Transmitted by the expert from Japan

Informal document No. GRSP-45-10
(45th GRSP, 25-29 May 2009,
agenda item 4(a))

Global technical regulation No. 9

PEDESTRIAN SAFETY

Figure 13: Flex-PLI; Dimensions and C.G. locations of femur, knee joint, and tibia (Side view)

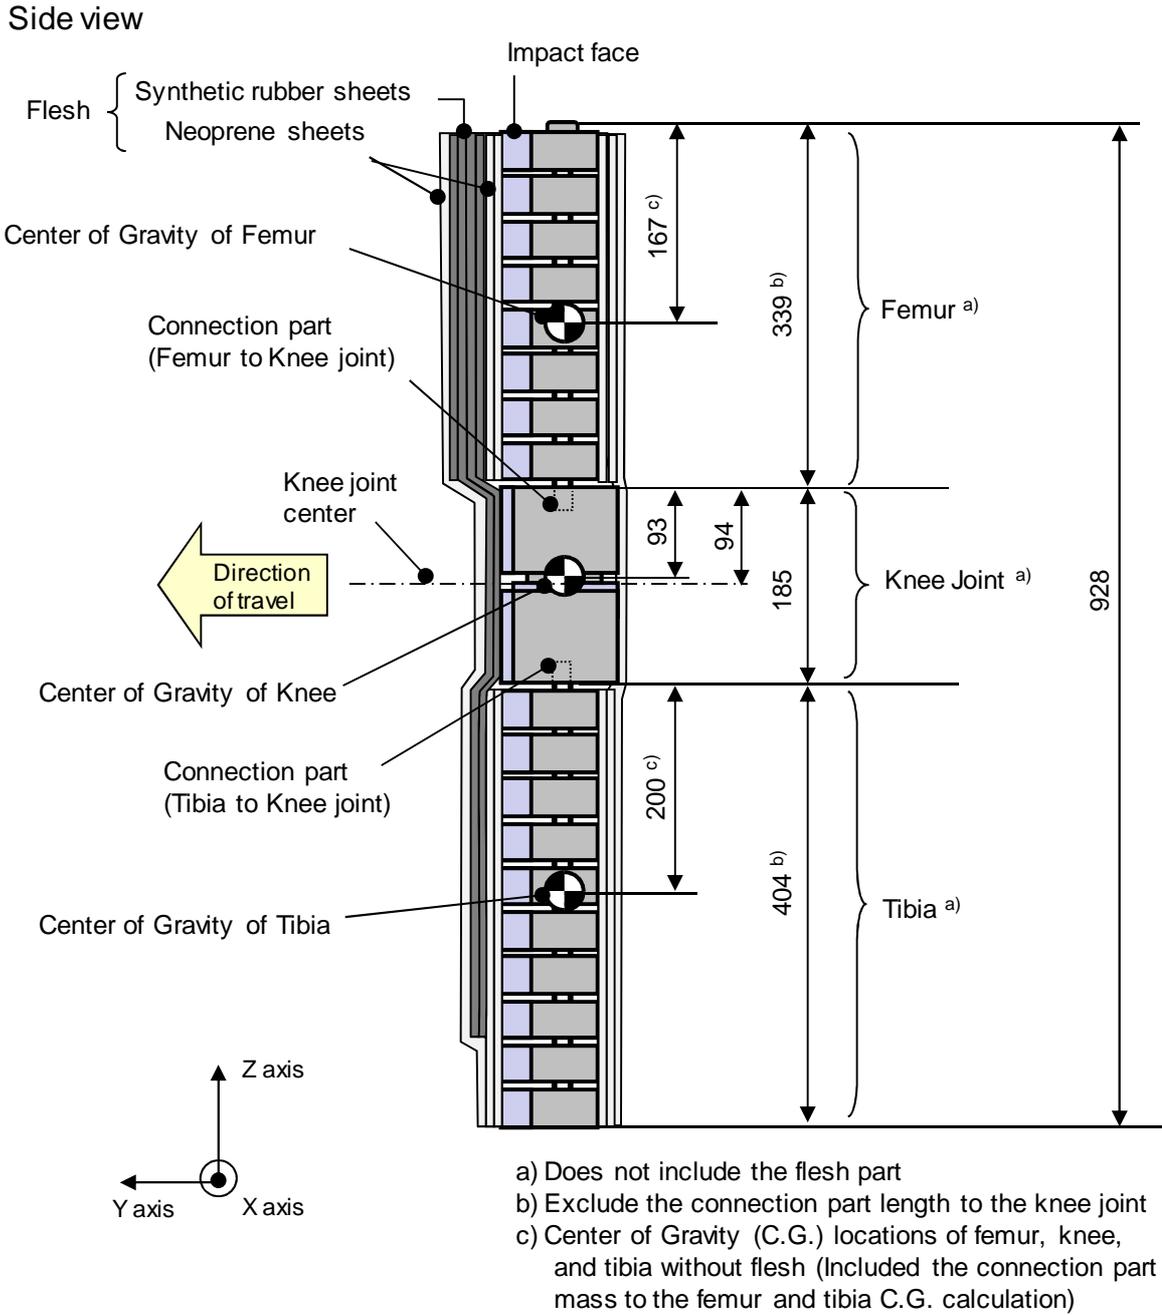
The lower legform impactor shall consist of flesh, flexible long bone segments (representing femur and tibia), and a knee joint as shown in Figure 13.

The centre of gravity of the femur and tibia without flesh, including the connection part to the knee joint, shall be $167 \pm [3]$ mm and $200 \pm [3]$ mm respectively from the top, but not including the connection part to the knee joint, of each part as shown in Figure 13. The centre of gravity of the knee shall be $93 \pm [3]$ mm from the top of the knee joint as shown in Figure 13.

Figure 14: Flex-PLI; femur, tibia, and knee dimensions (Top view)

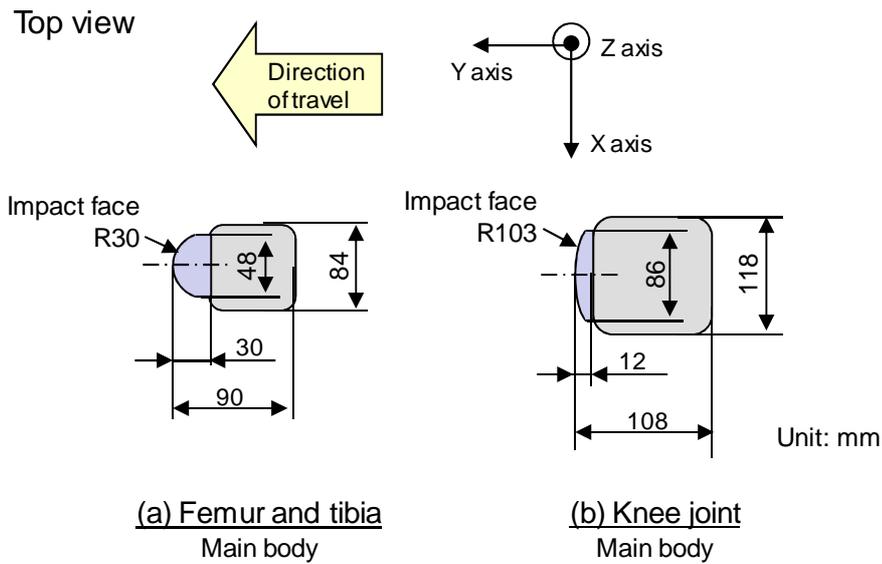
- 6.3.1.2.1. The cross-sectional shape perpendicular to the Z axis of the femur and tibia main bodies shall be $90 \pm [2]$ mm in width along the Y axis, and $84 \pm [1]$ mm in width along the X axis as shown in Figure 14 (a). The impact face shall be $30 \pm [1]$ mm in radius, $30 \pm [1]$ mm in width along the Y axis, and $48 \pm [1]$ mm in width along the X axis as shown in Figure 14 (a).

- 6.3.1.2.2. The cross-sectional shape perpendicular to the Z axis of the knee joint shall be $108 \pm [2]$ mm in width along the Y axis, and $118 \pm [1]$ mm in width along the X axis as shown in Figure 14 (b). The impact face shall be $103 \pm [1]$ mm in radius, $12 \pm [1]$ mm in width along the Y axis, and $86 \pm [1]$ mm in width along the X axis as shown in Figure 14 (b).

Figure 15: Flex-PLI; flesh dimensions and mass

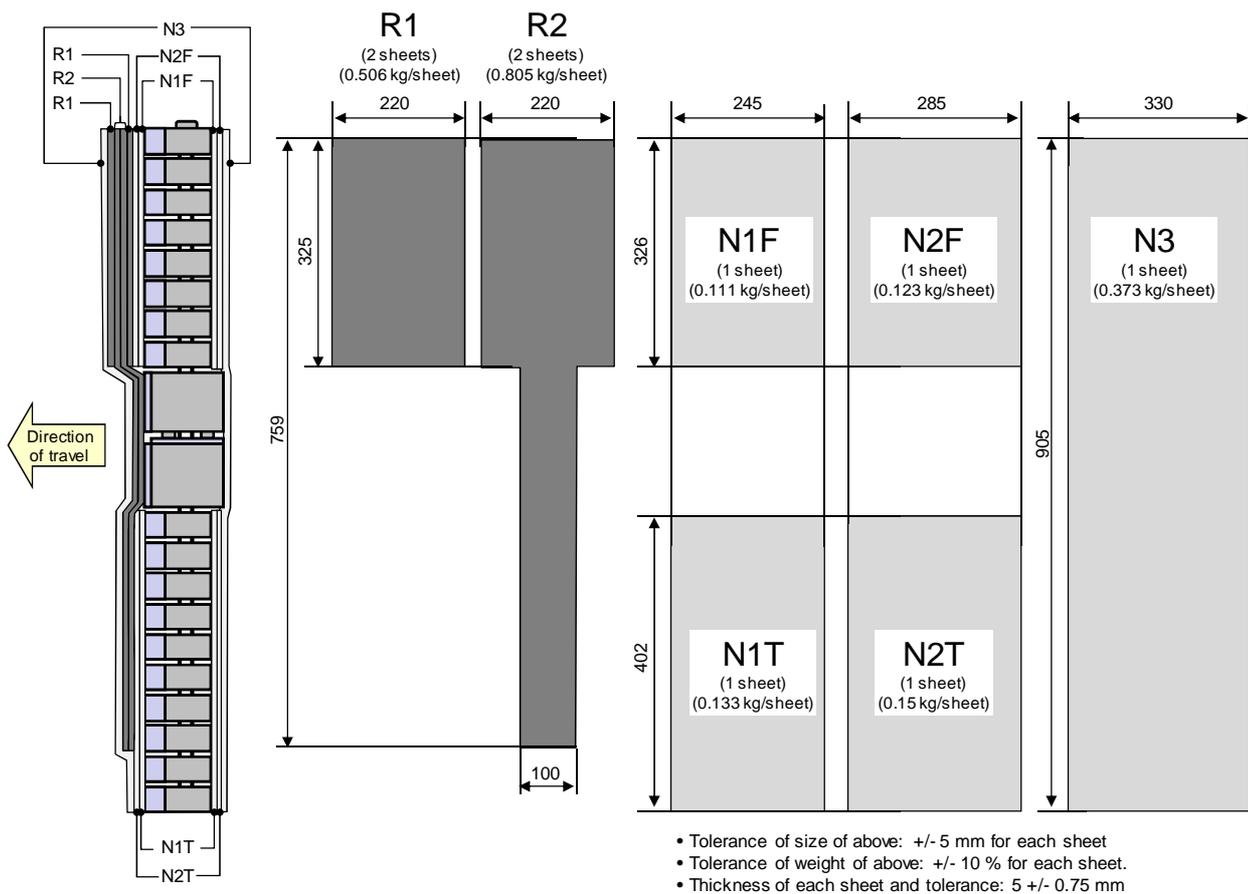
- 6.3.1.2.4. For each test, the impactor (femur, knee joint, and tibia) shall be covered by flesh composed of synthetic rubber sheets (R1, R2) and neoprene sheets (N1F, N2F, N1T, N2T, N3) as shown in Figure 15. The sheets are required to have a compression characteristic as shown in Figure 16. The compression characteristic shall be checked using the same batch of sheets as those used for the impactor flesh. The size and weight of the sheets shall be within the requirements described in Figure 16.
- 6.3.1.2.5. The test impactor or at least the flesh shall be stored for at least four hours in a controlled storage area with a stabilised temperature of $20 \pm 4^{\circ}\text{C}$ prior to impactor removal for calibration. After removal from the storage, the

Figure 17: Flex-PLI; instrument locations

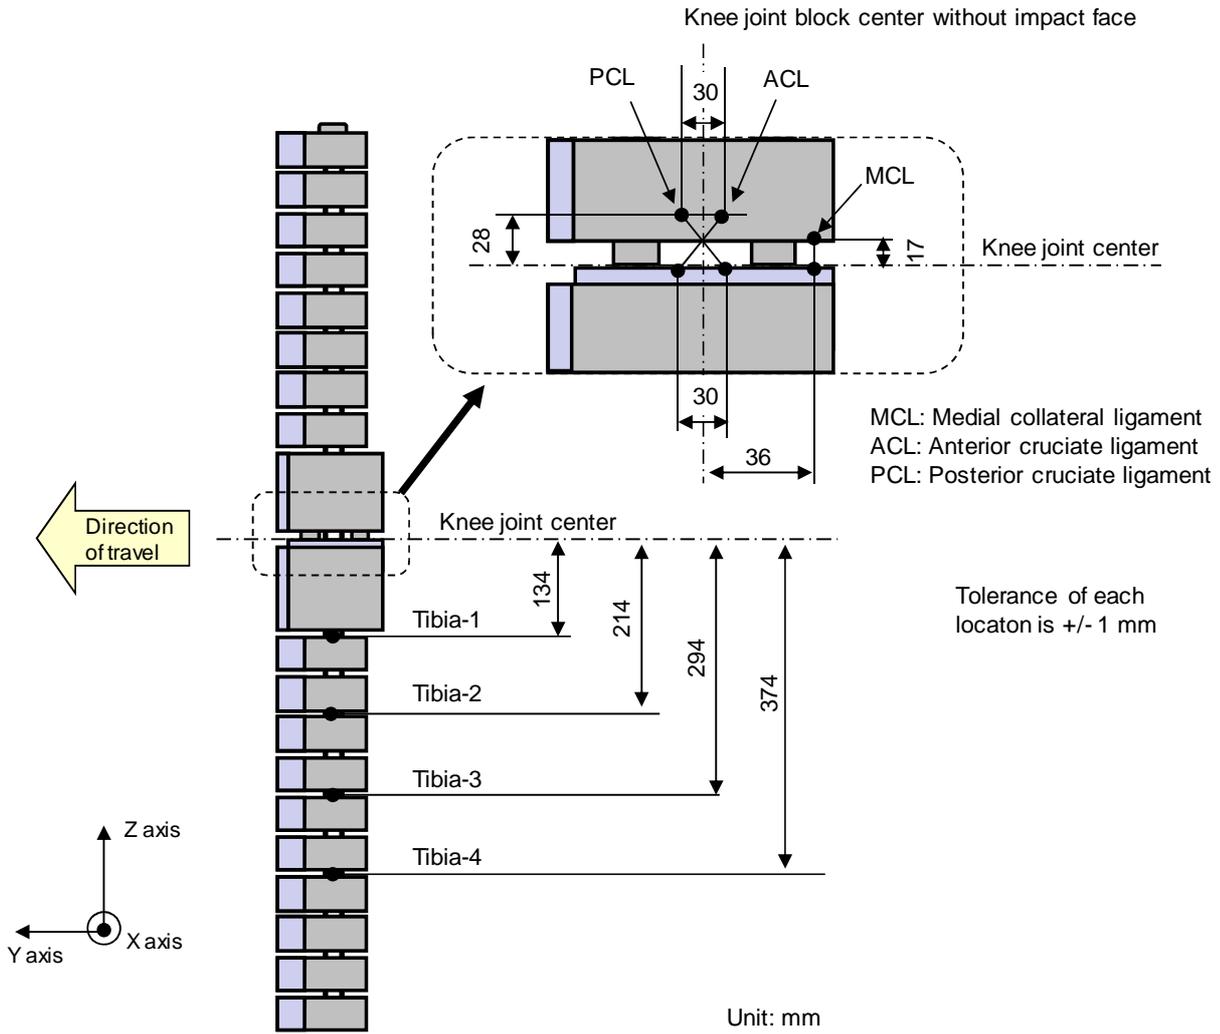
6.3.1.2.6.1. Four transducers shall be installed in the tibia to measure bending moments applied to the tibia. The sensing locations of each of the transducers are as follows: tibia-1: $134 \pm [1]$ mm, tibia-2: $214 \pm [1]$ mm, tibia-3: $294 \pm [1]$ mm, and tibia-4: $374 \pm [1]$ mm below the knee joint centre respectively as shown in Figure 17. The measurement axis of each transducer shall be the X axis of the impactor.

6.3.1.2.6.2. Three transducers shall be installed in the knee joint to measure elongations of the medial collateral ligament (MCL), anterior cruciate ligament (ACL), and posterior cruciate ligament (PCL). The measurement locations of each transducer are shown in Figure 17. The measurement locations shall be within $\pm [3]$ mm along the X axis from the knee joint centre.

Figure 23: Tolerances of angles for the lower legform impactor at the time of the first impact (see paragraphs 7.1.2.2. and 7.1.2.3.2.)

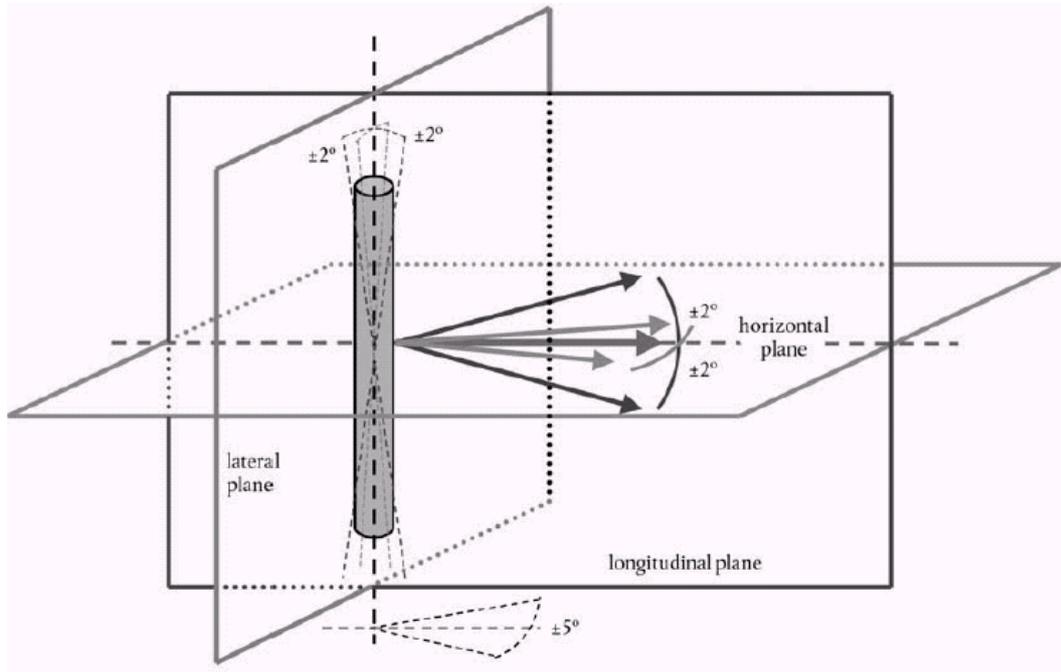
7.1.2.2. The direction of the impact velocity vector shall be in the horizontal plane and parallel to the longitudinal vertical plane of the vehicle. The tolerance for the direction of the velocity vector in the horizontal plane and in the longitudinal plane shall be $\pm 2^\circ$ at the time of first contact. The axis of the impactor shall be perpendicular to the horizontal plane with a tolerance of $\pm 2^\circ$ in the lateral and longitudinal plane. The horizontal, longitudinal and lateral planes are orthogonal to each other (see Figure 23).

7.1.2.3.2. At the time of first contact the impactor shall have the intended orientation about its vertical axis, for the correct operation of its knee joint, with a tolerance of $\pm 5^\circ$ (see Figure 23).

Figure 24: Flex-PLI to bumper tests for complete vehicle in normal ride attitude (left) and for cut-body mounted on supports (right) (see paragraph 7.1.2.3.)

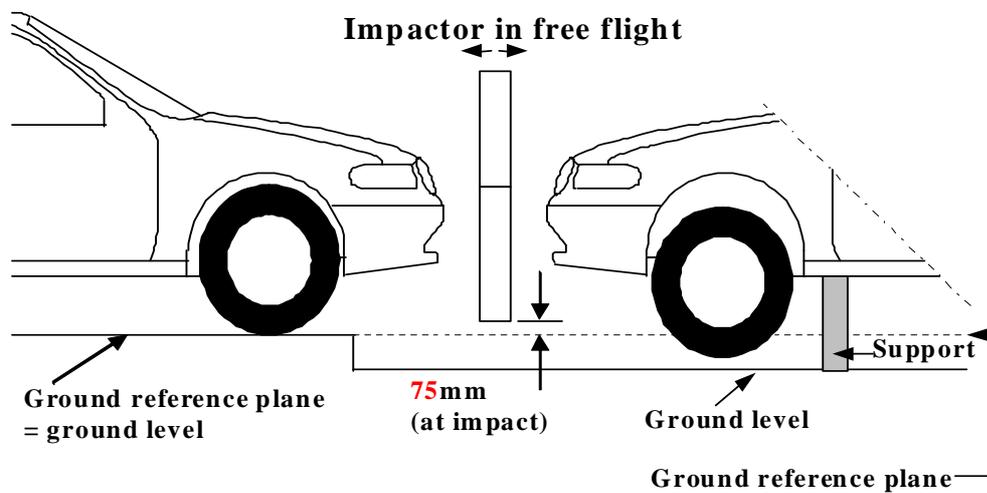
7.1.2.3. The bottom of the impactor shall be at 75 mm above ground reference plane at the time of first contact with the bumper (see Figure 24), with a ± 10 mm tolerance. When setting the height of the propulsion system, an allowance must be made for the influence of gravity during the period of free flight of the impactor.

Figure 31: Requirement corridor of femur and tibia in static certification test (see paragraph 8.2.1.2.)

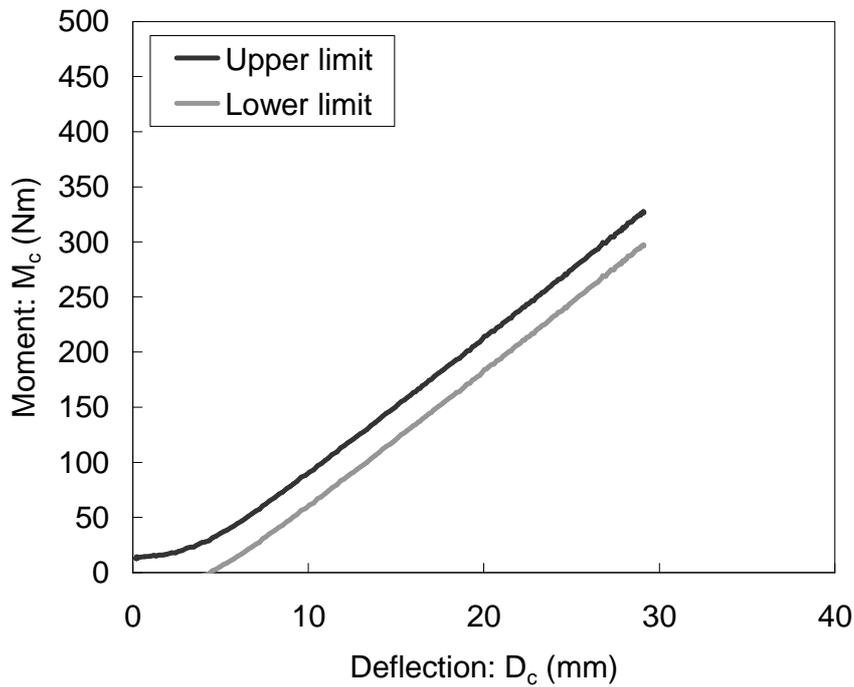
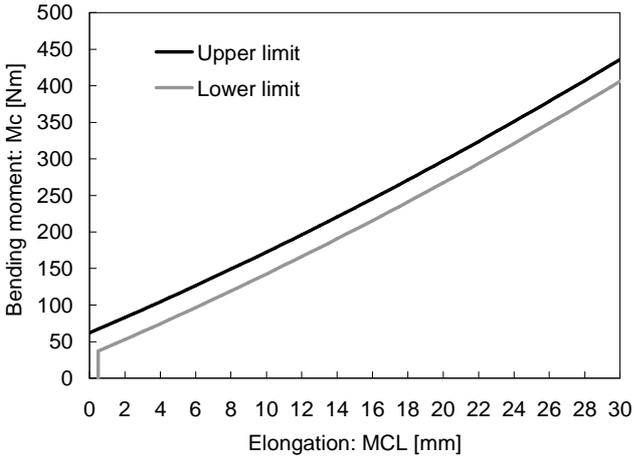
8.2.1.2. When the femur and tibia of the impactor are loaded in bending in accordance with paragraph 8.2.1.4., the applied moment and generated deflection at the centre of the femur and tibia (M_c and D_c) shall be within the corridors shown in Figure 31.

Figure 32: Requirement corridors for knee joint in static certification test (see paragraph 8.2.1.3.)

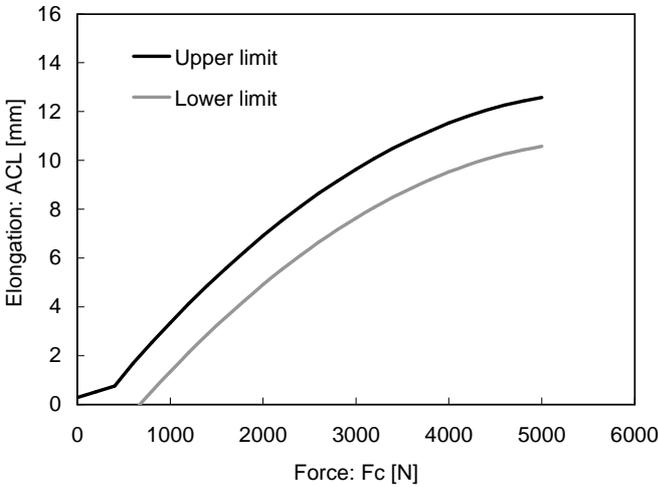
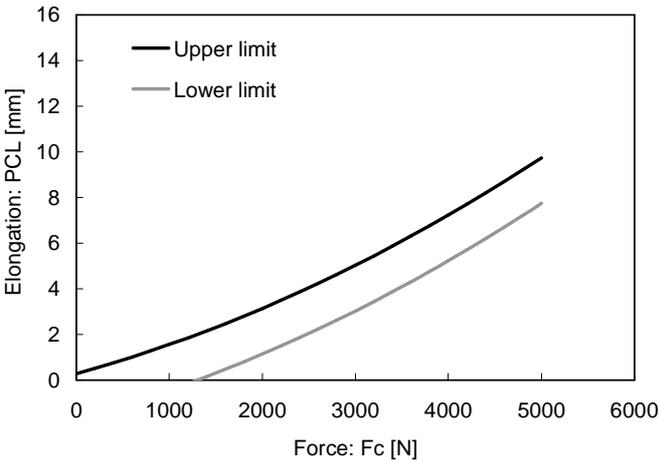
8.2.1.3. When the knee joint of the impactor is loaded in bending in accordance with paragraph 8.2.1.5., the MCL, ACL, and PCL elongations and applied bending moment or force at the centre of the knee joint (M_c or F_c) shall be within the corridors shown in Figure 32.

Figure 33: Test set-up for femur in static certification tests
 (see paragraph 8.2.1.4.)

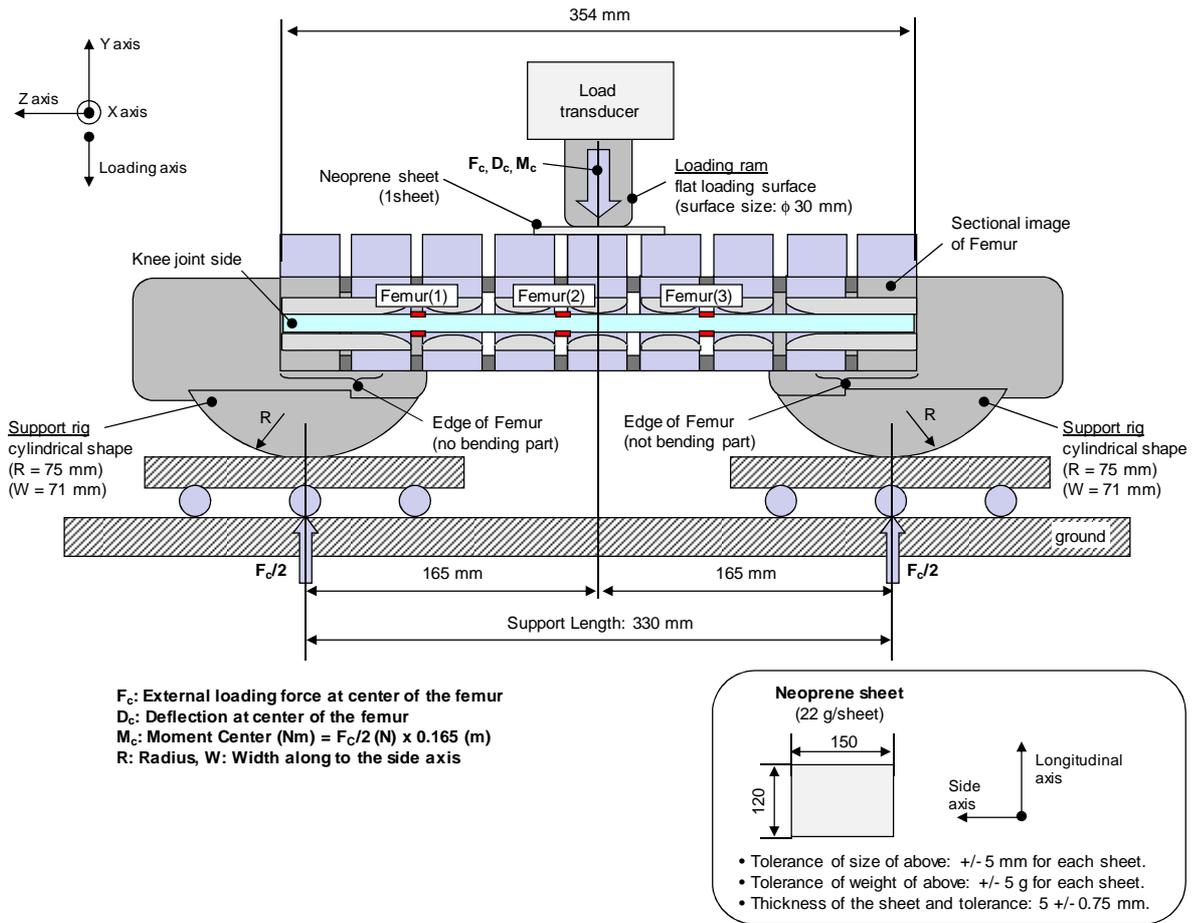
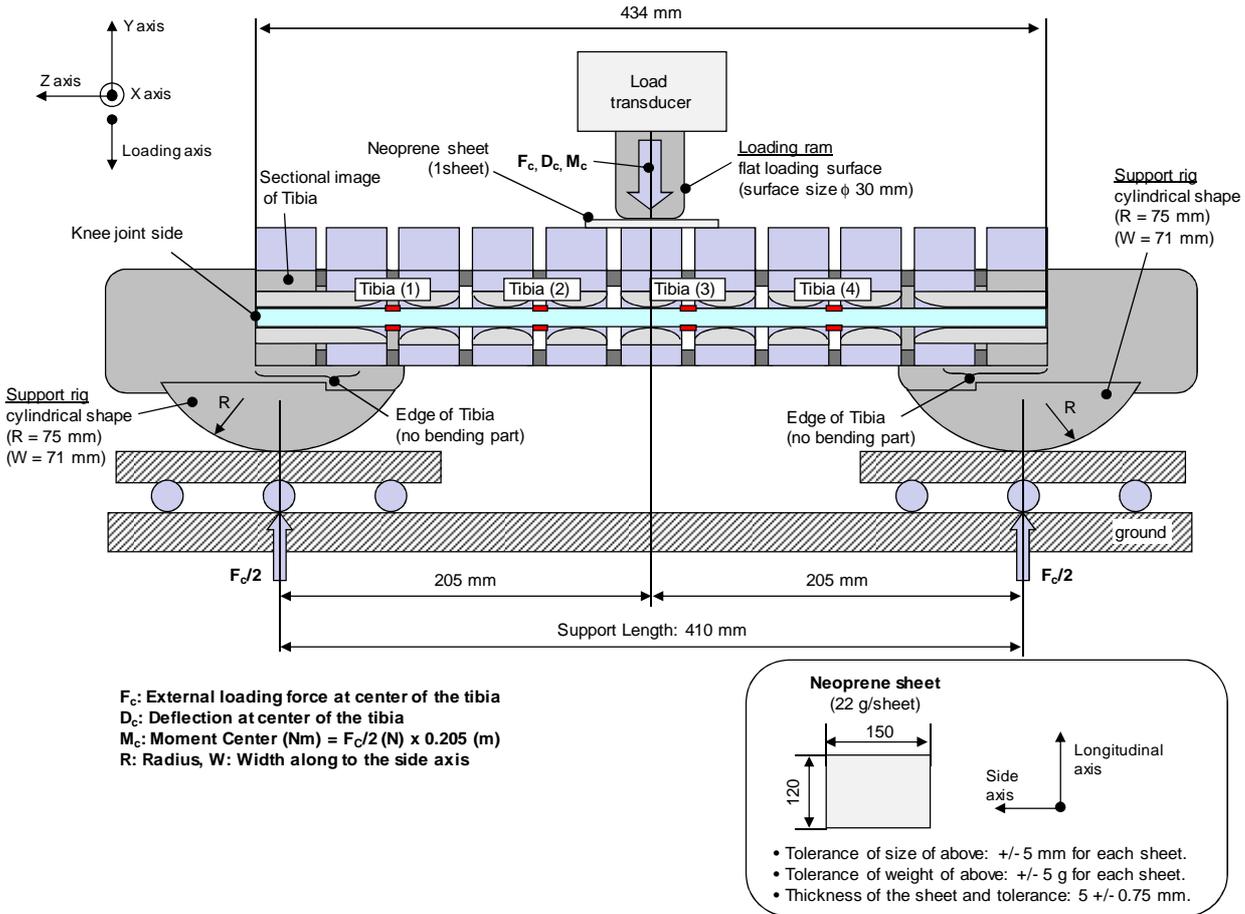
8.2.1.4. The edges, of the femur and tibia, not bending parts, shall be mounted to the support rig firmly as shown in Figure 33. The Y axis of the impactor shall be parallel to the loading axis within $180 \pm 2^{\circ}$ tolerance. In order to avoid friction errors, roller plates shall be set underneath the support rigs. To avoid impactor damage, a neoprene sheet shall be set underneath the loading ram. The neoprene sheet used in this test shall have compression characteristics as shown in Figure 16.
